Access Compliance Report

Public Rights-of-Way

(Pedestrian Signals)

Intersection ID: N/A	Main Street:	Cross Street: N/A	Location: N/A
ADA ID: 614A2A0D6D95	Signal Type: Two Push Buttons-Non APS	Overall Compliance: No	Severity Score: BTN 1:N/A BTN 2: N/A No BTN: N/A
Codes/Mitigation Info/Possible Solution		Field Measurements/Component Compliance

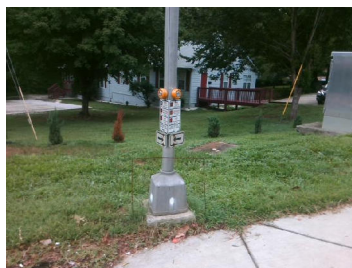
PROW/ADA: TMUTCD 4e.08, R404.2, R404.3, R406.2

Possible Solutions: Replace Signal Push Button With APS Button on New Post. Remove & Relocate Sign.
